III. REVISIONS, CLARIFICATIONS, AND CORRECTIONS TO THE DRAFT EIR

Fourth & Central Project

8. Pages II-14 to II-18, Subsection 4.a)(1), *Project Overview*, revise the following figures: Figure II-5, *Proposed Program Diagram*; Figure II-6, *Conceptual Site Plan*; Figure II-7, *Ground Level Plan*; Figure II-8, *Site Dimensions and Building Heights*, and Figure II-9, *Ground Level Uses*.

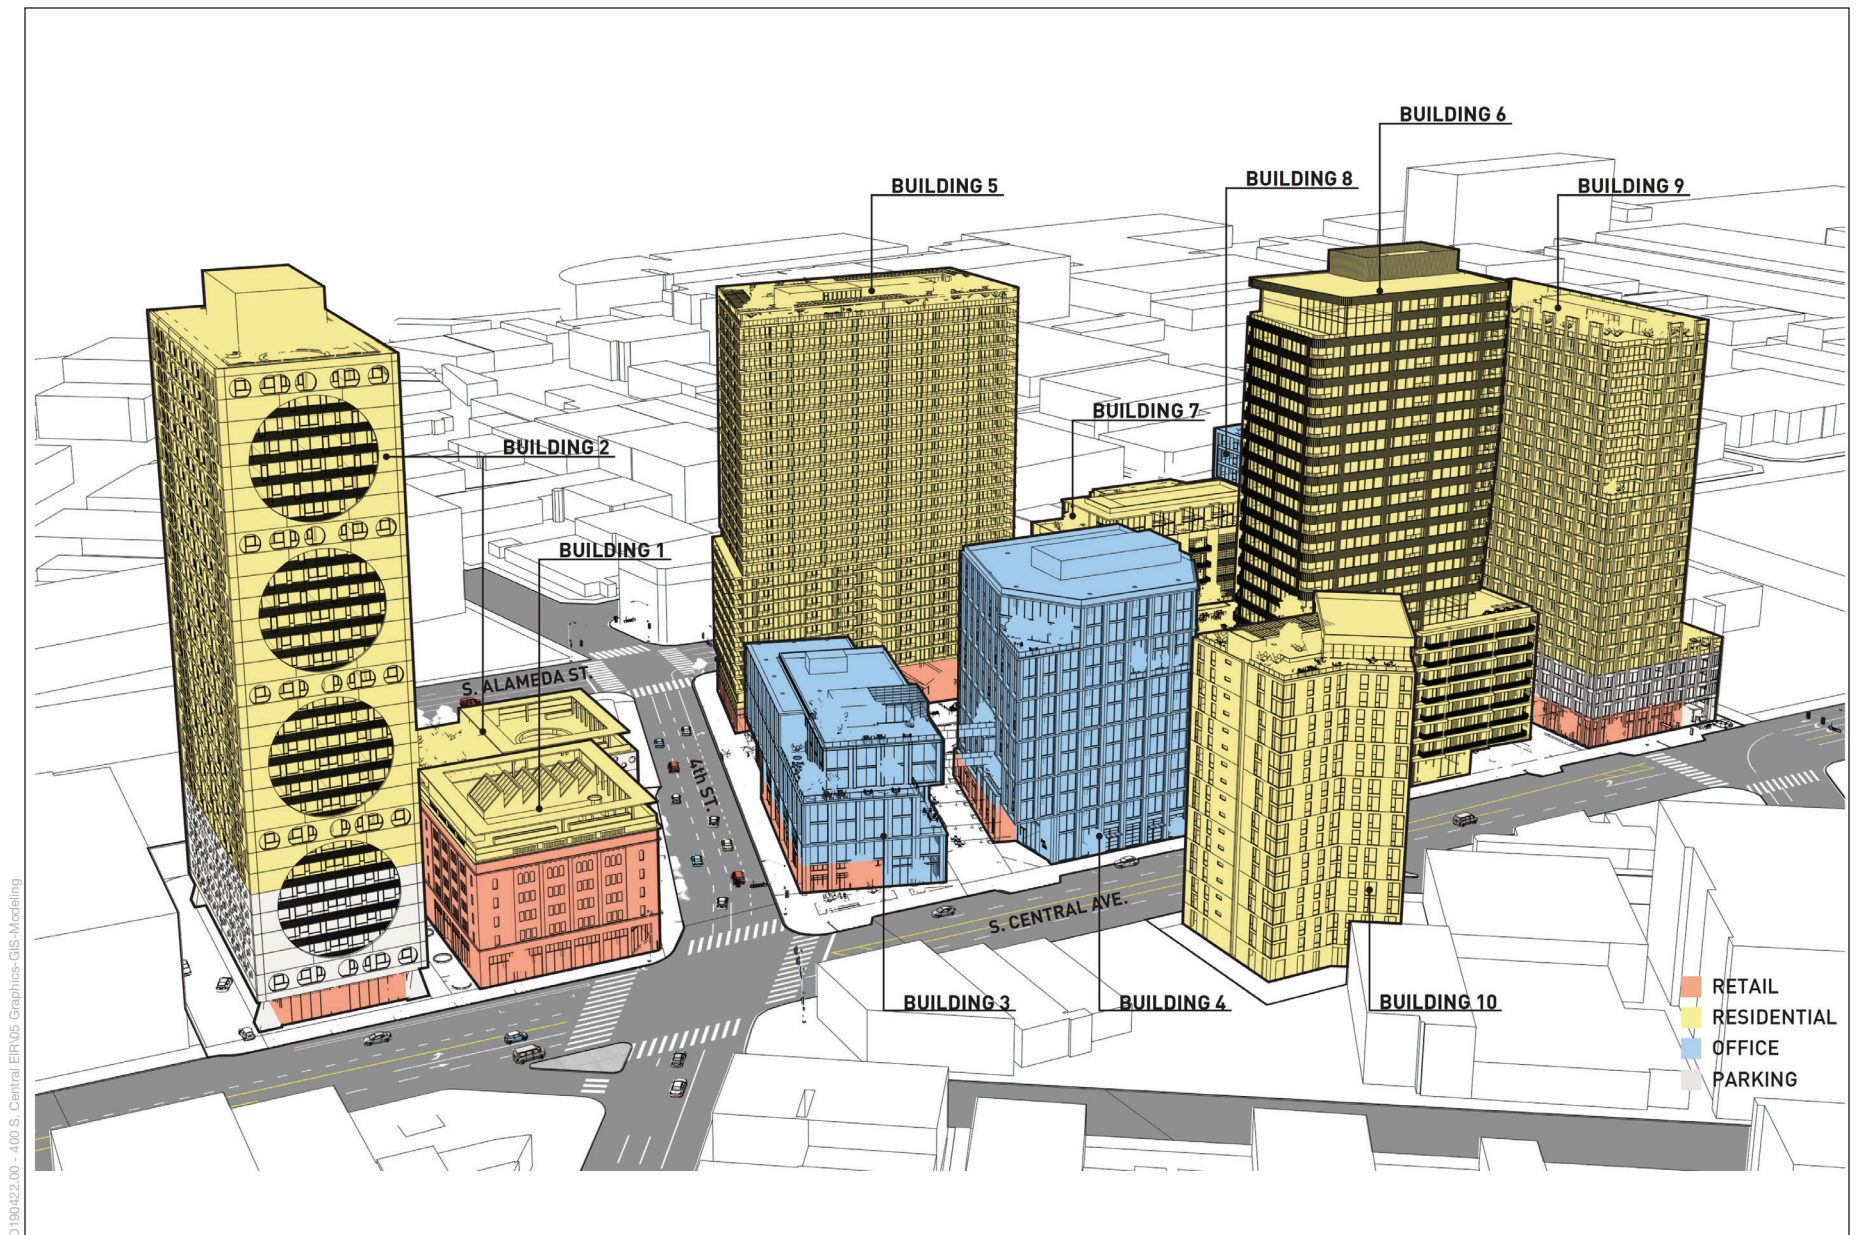
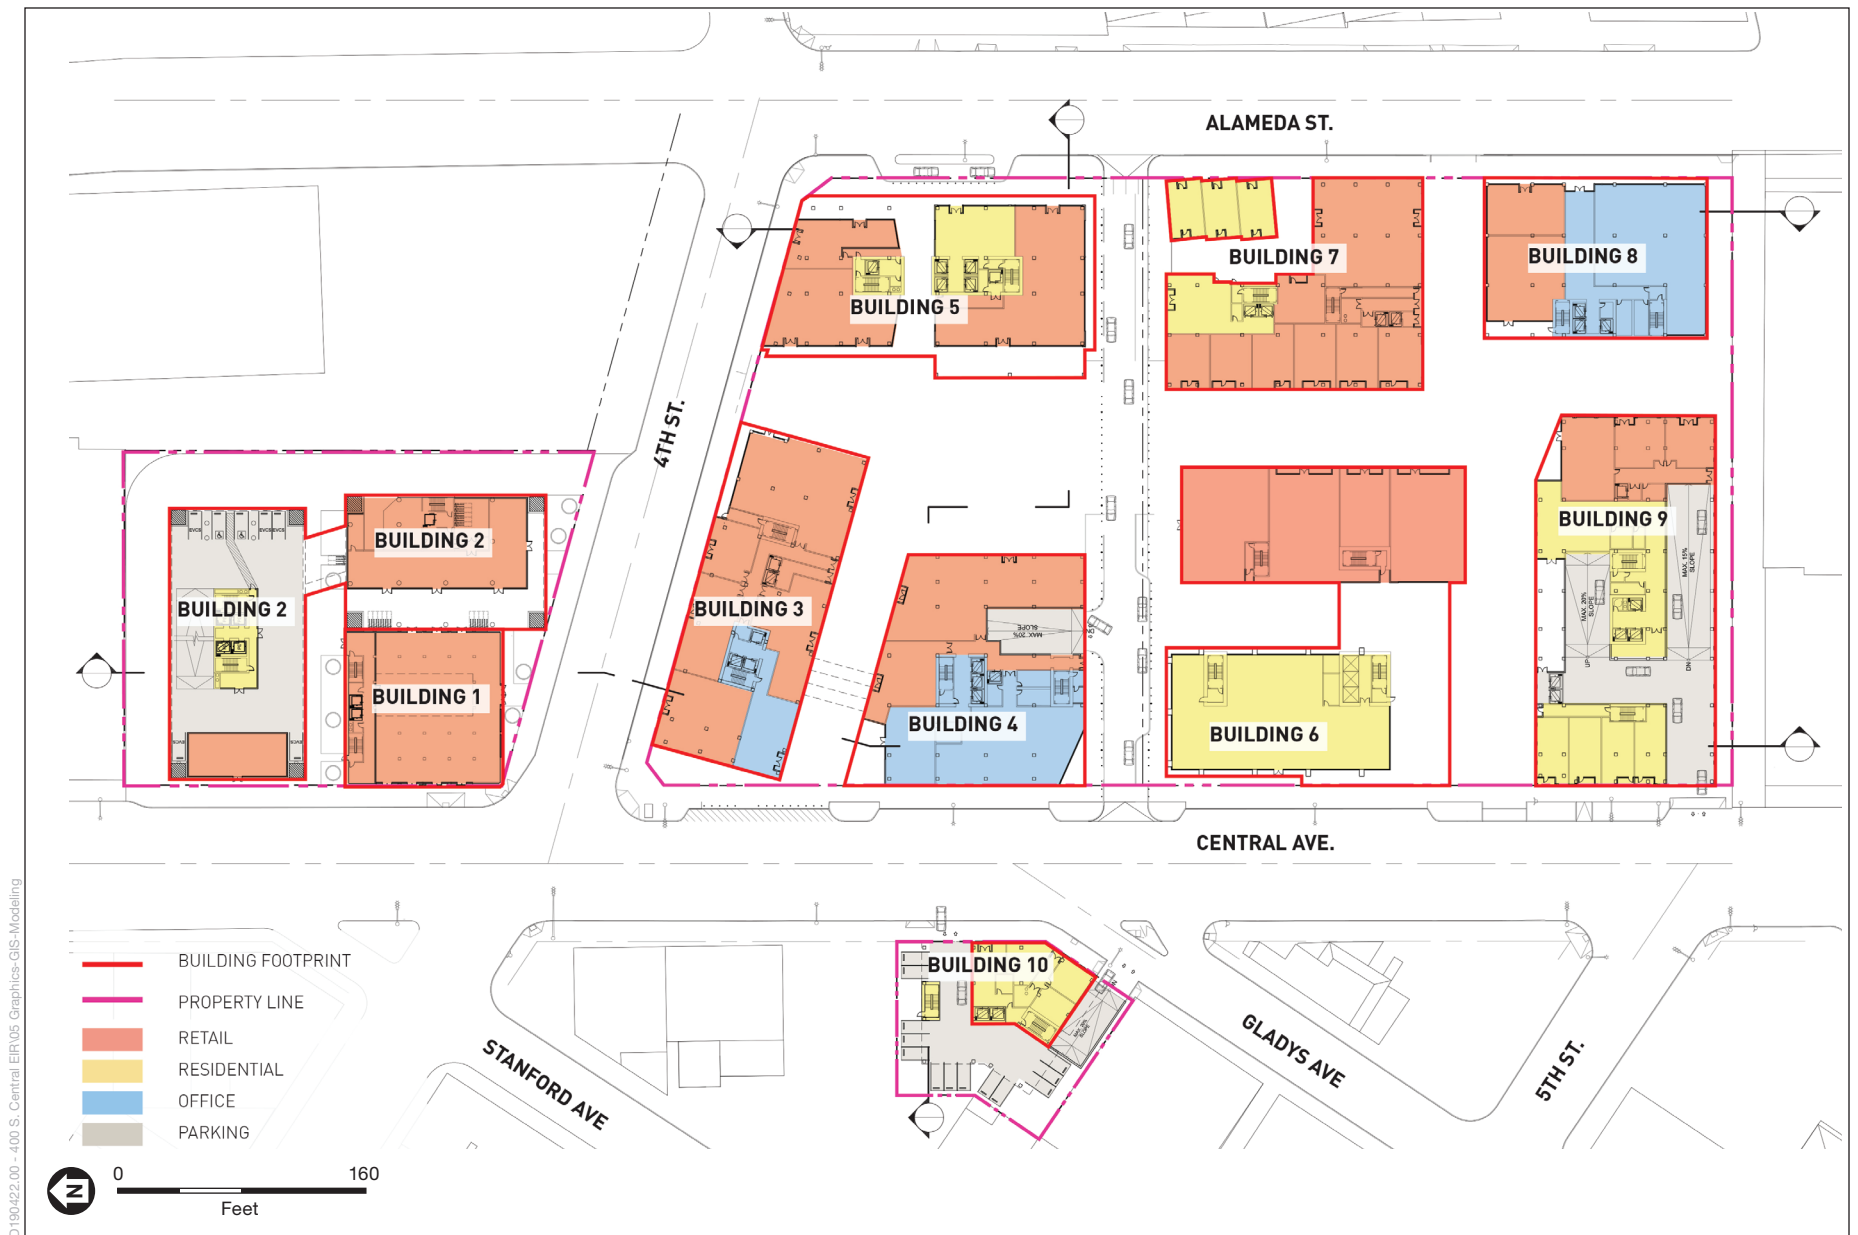
Figure II-9, *Ground Level Uses*, shows the breakdown between retail (including restaurant), residential, and office, ~~and hotel~~ uses occurring at the first-floor level.

Figure II-10
Publicly-Accessible Open Space Plan

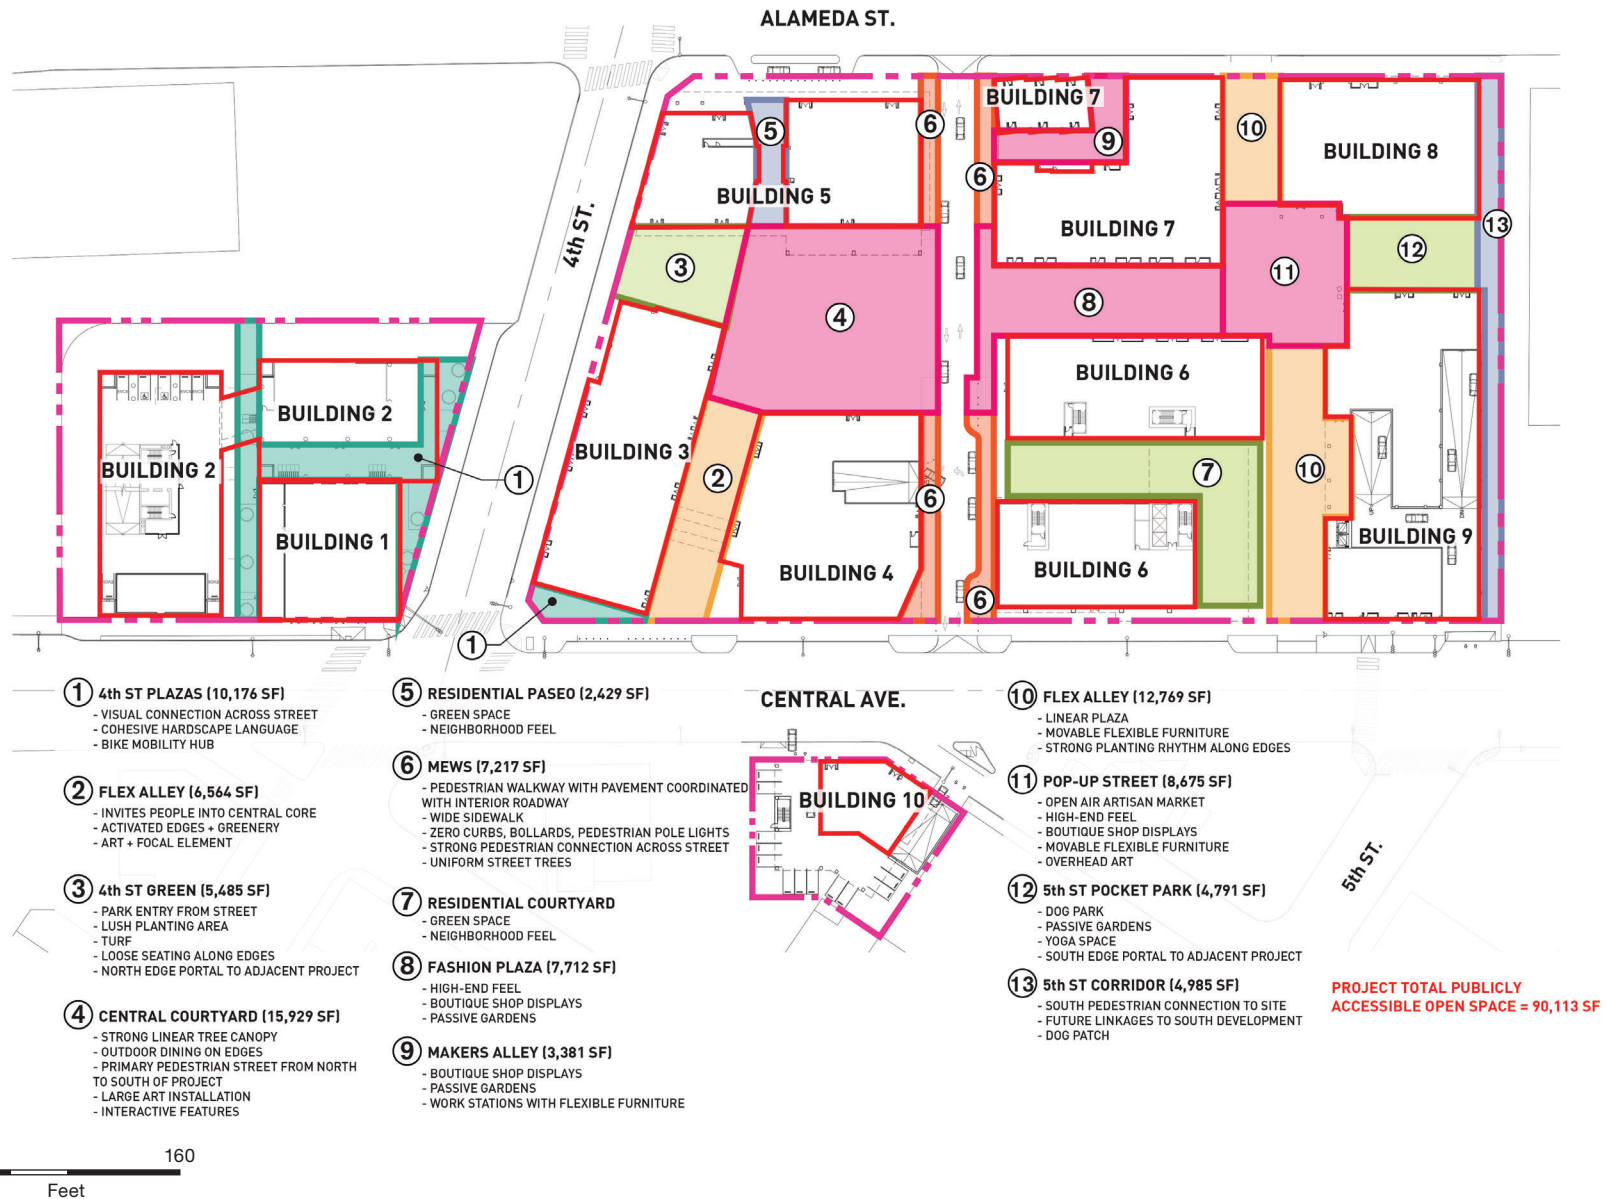
15. Page II-20, Subsection 4.a)(1)(a), *North Site – Buildings 1 and 2*, revise Figure II-10, *Publicly-Accessible Open Space Plan*.

Figure II-11
Project Site Section from Central Avenue

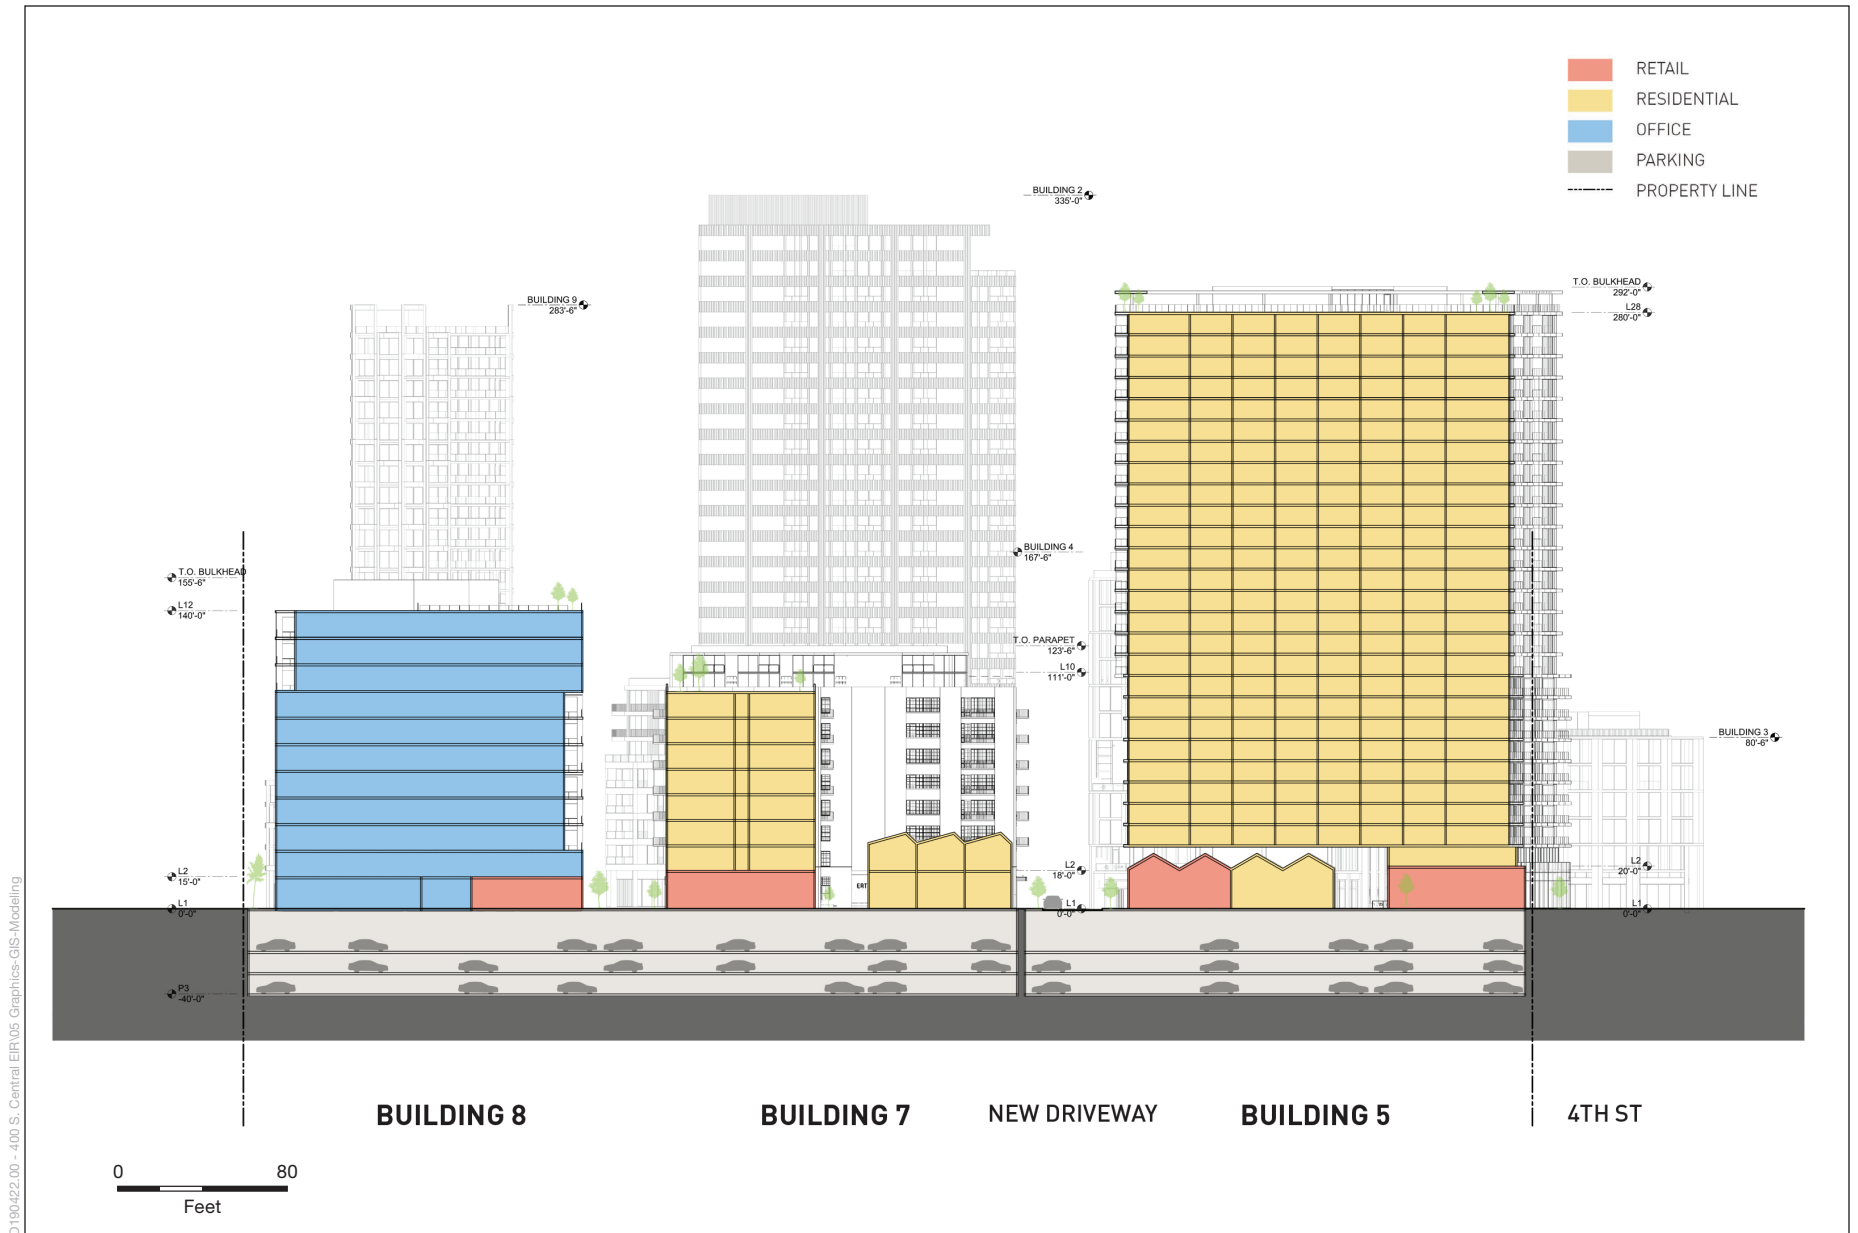
20. Pages II-25 to II-27, Subsection 4.a)(2), *Architecture and Design*, revise the following figures: Figure II-11, *Project Site Section from Central Avenue*; Figure II-12, *Project Site Section from Alameda Street*; and, Figure II-13, *Project Site Section as Viewed from the South*.
